STAFF REPORT

RE: Woodlawn Project – Proposed Change Orders 1 and 2

Ref: Woodlawn – 37th Street North to 45th Street North; **PCO #: 001**

Ref: Woodlawn – 37th Street North to 45th Street North; **PCO #: 002**

PLAN WATER LINE_1

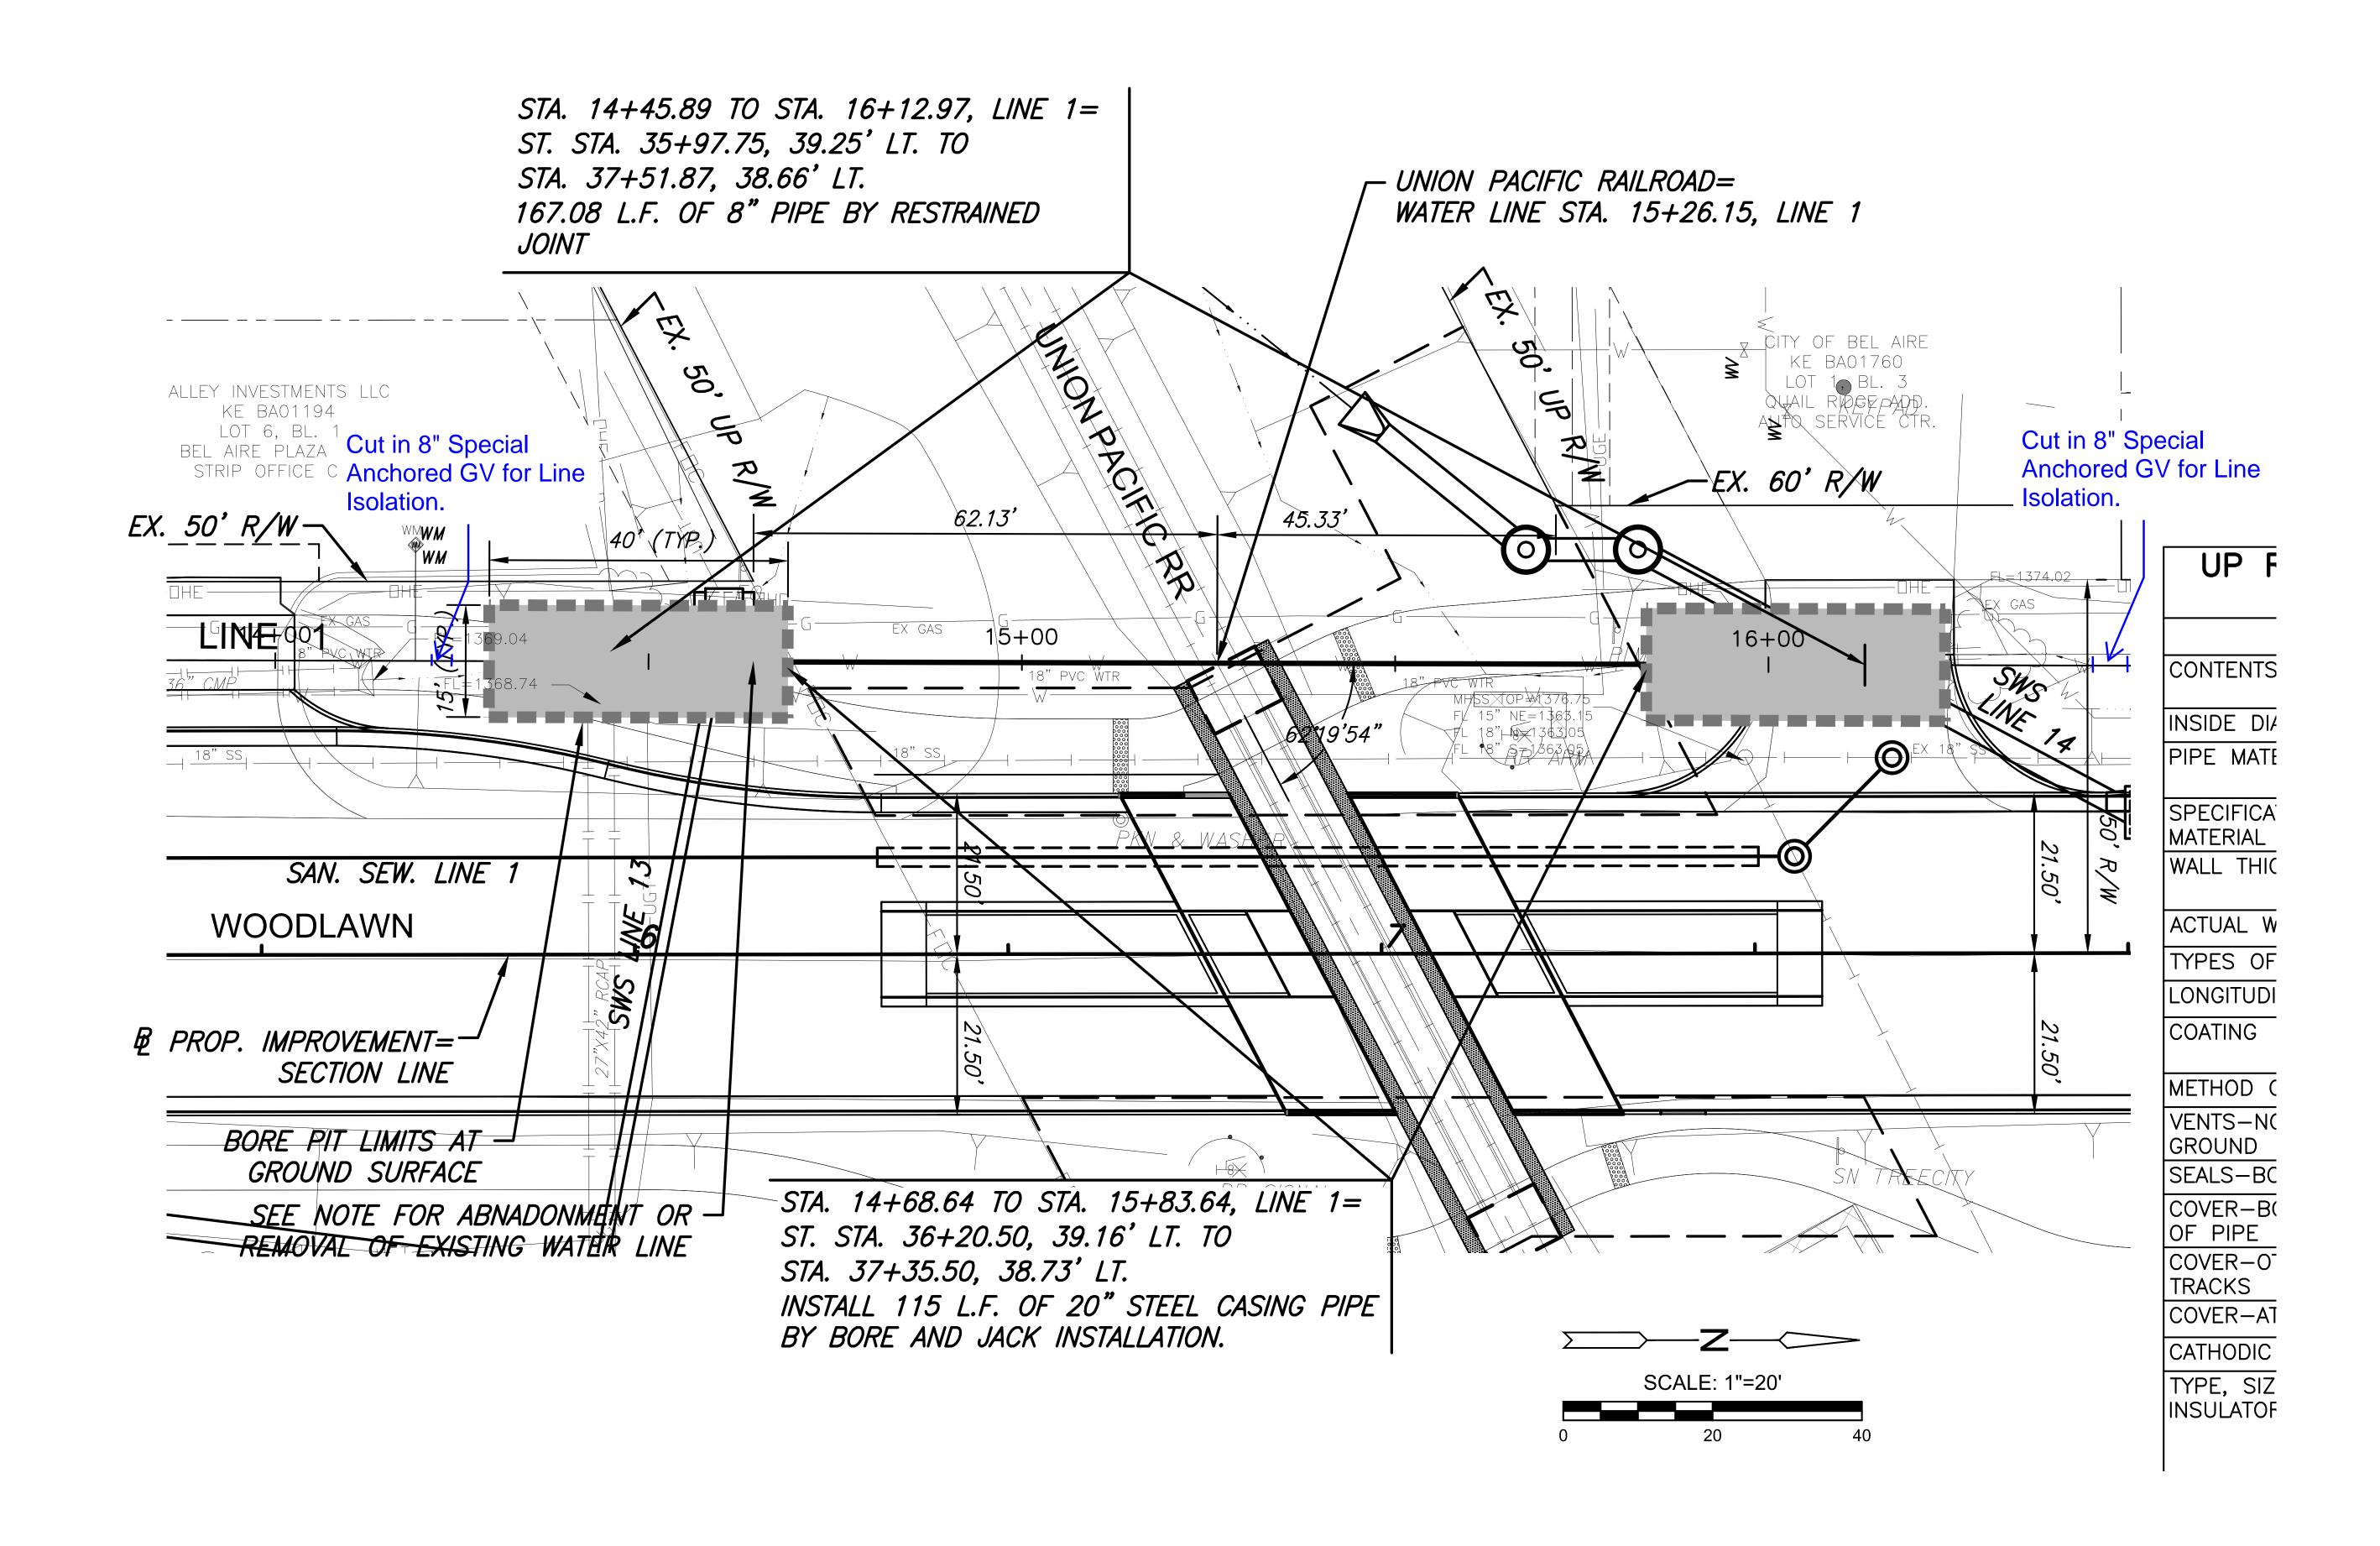
As the Contractor prepares for the water line bore underneath the railroad, they ran into a potential conflict with the installation of the new casing as it is too close to the existing casing to execute the bore as proposed. Additionally, when researching the proposed shutdown for the bore, they noticed that there is no clean way to shut off this area of main without disrupting the water service to a large number of houses.

As the Contractor was preparing for the bore and the construction foreman was reviewing the plans, it came to their attention that there is potentially a conflict with the installation of the water line casing pipe as shown in the plans. It is the opinion of the foreman that the existing casing and proposed casing are too close together to execute the bore as proposed – there needs to be a certain amount of separation to ensure the safety and integrity of the existing water line as it remains in service. The second concern is the number of houses and businesses that will have their service interrupted due to the work and the proximity of the two lines.

The first is the installation of two water valves on either side of the bore. These valves would allow us to isolate the water line underneath the railroad, while allowing customers on either side of the railroad to remain in service. Dondlinger's proposal for this change order is \$22,000.00.

The second change order provides two options for addressing the concern about the proposed and existing casing being too close together to be able to safely install. The first option is to utilize the existing casing, remove the existing waterline and thread a new waterline through the existing casing. This is largely determinant on the state of the existing casing and the ease of finding spacers or suitable interstitial fill material to allow the new water main pipe to be suspended in the casing pipe. This option will include a deduct for the new steel casing pipe minus the cost of the restocking fee since the pipe has already been purchased. The second option for addressing the concern is to lower the new water line below the existing casing pipe so a safe distance is achieved for the boring of the new casing pipe. Dondlinger's proposal for Option 1 is \$22,500.00. Their proposal for Option 2 is \$9,250.00.

New Item – Cut in & Install (2) 8" Gate Valves

8" MJ Gate Valves, Valve Boxes, Flush Stations, Tracer Connectors, and Anodes.

Anchoring Materials for the two New Special Type Gate Valves.

Small Section of DICL Pipe, Polywrap, Poly Tape, DI and PVC Restraints, and Sleeves.

Bedding materials for New Pipe Components and Fittings.

Fill Sand for Approx 20ft on Each Side of Pipe Next to Cut In Location.

Labor and equipment cost to cut in and install the (2) Gate Valves and all Components.

Staff recommends Council approve Proposed Change Order #1 for the 8" Gate Valves on either side of the railroad bore. The gate valves would provide additional flexibility to the water system and could prevent prolonged water outages for approximately 16 customers that are directly served by this area.

Staff also recommends that Council approve Proposed Change Order #2 – Option 2 for the re-use of the existing casing pipe – provided that it is in good condition and works with the available materials. This option will presumably save both time and cost by allowing the Contractor to repurpose some of the existing infrastructure.
